Re: Clawe – Comprehensive Permit Plan Changes

Plan Title:	Lot 1 Septic and Well Plan		
Project Name:	Greenwood Street Homes		
Site Address:	0 Washington St (Map 7, Lot 49) - Sherborn, MA		
Owner:	AB Realty Trust	Client:	Robert Murchison
Project No:	J269-19a	Drawn by:	F.A.
Designed by:	DSW/FA	Approved by:	DSW
Scale:	Indicated		
Rev.:	12/18/23	Leaching field, minor grading around SAS	DSW/FA
Date:	12/05/23	General notes, house and driveway, grading, septic inverts & features	DSW/FA
Description:			
By:	A. Murchison

Plan Title: Lot 2 Septic and Well Plan

Plan Title: Lot 3 Septic and Well Plan

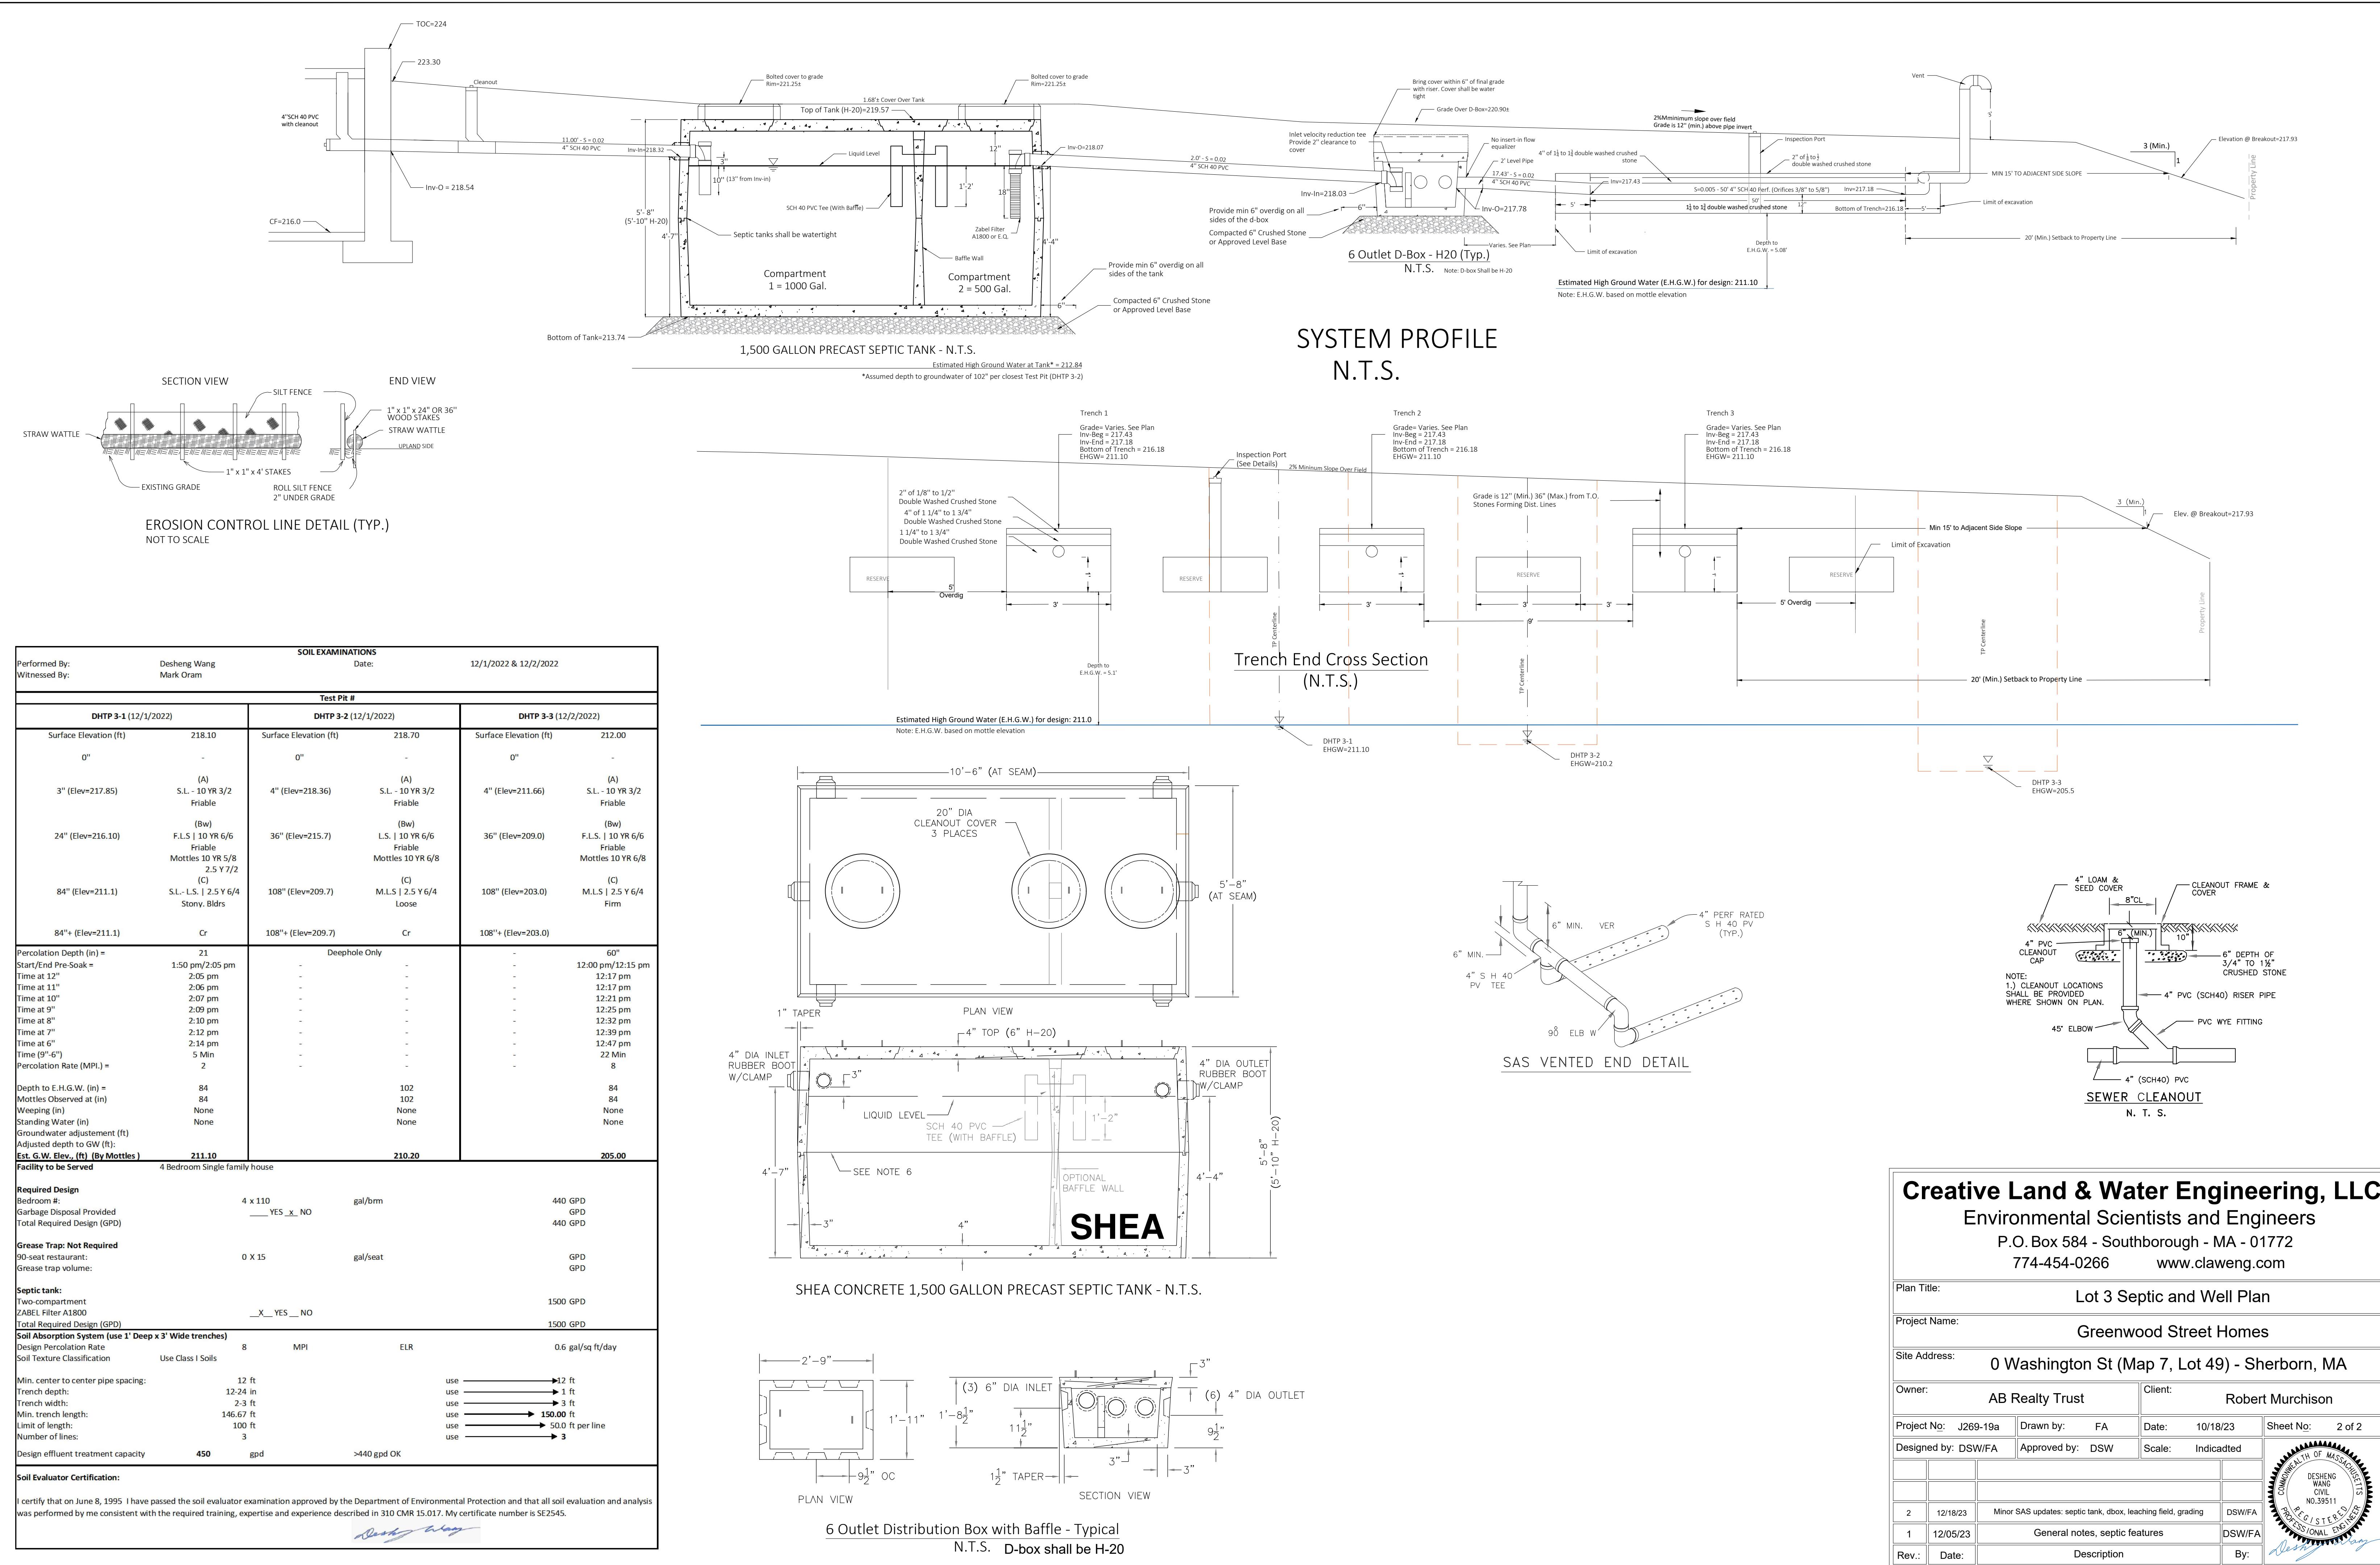
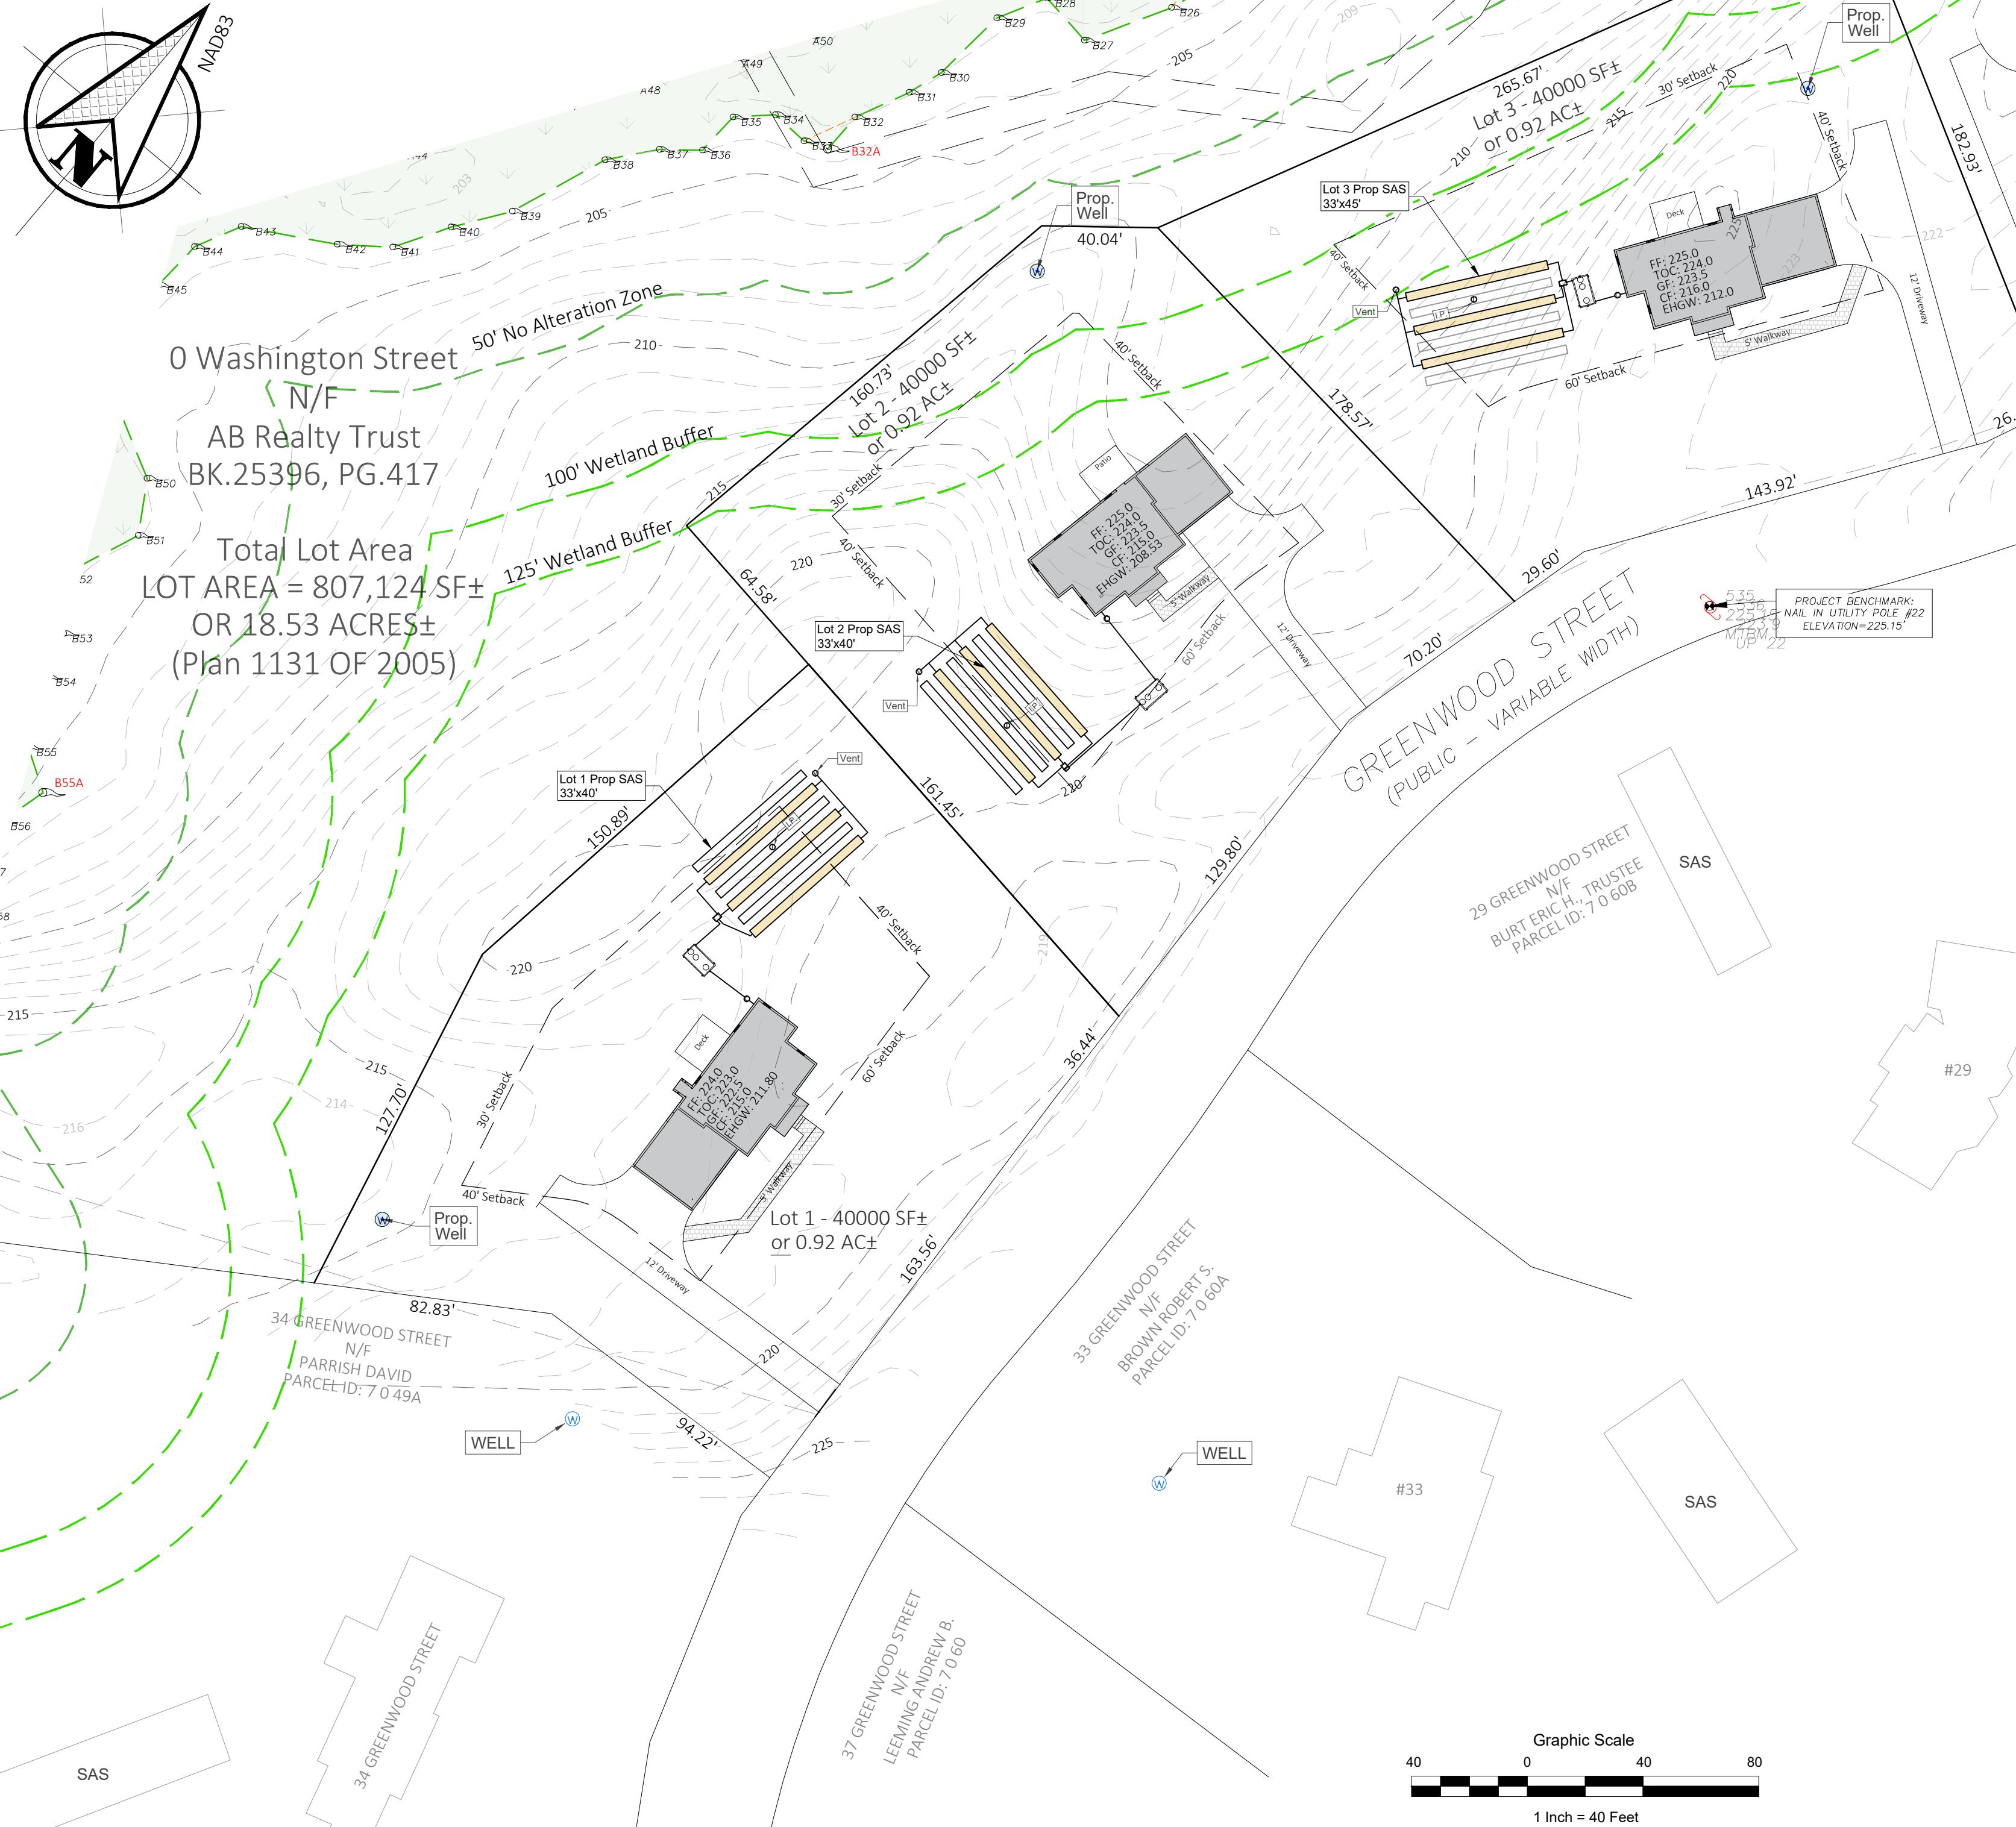
- On Lot 1, the well location shown for the abutting well at 34 Greenwood has been updated to better reflect the "as-built" plan provided by Sherborn BOH. Note the location previously shown was a more conservative estimate based on GIS. All required setbacks have been updated.
- On Lot 1, 2 and 3, the SAS has been resized to reflect the Health Agent's differing characterization of the soil type. Again, all required setbacks have been updated.

2 12/18/23 Minor SAS updates: septic tank, dbox, leaching field, grading DSW/FA
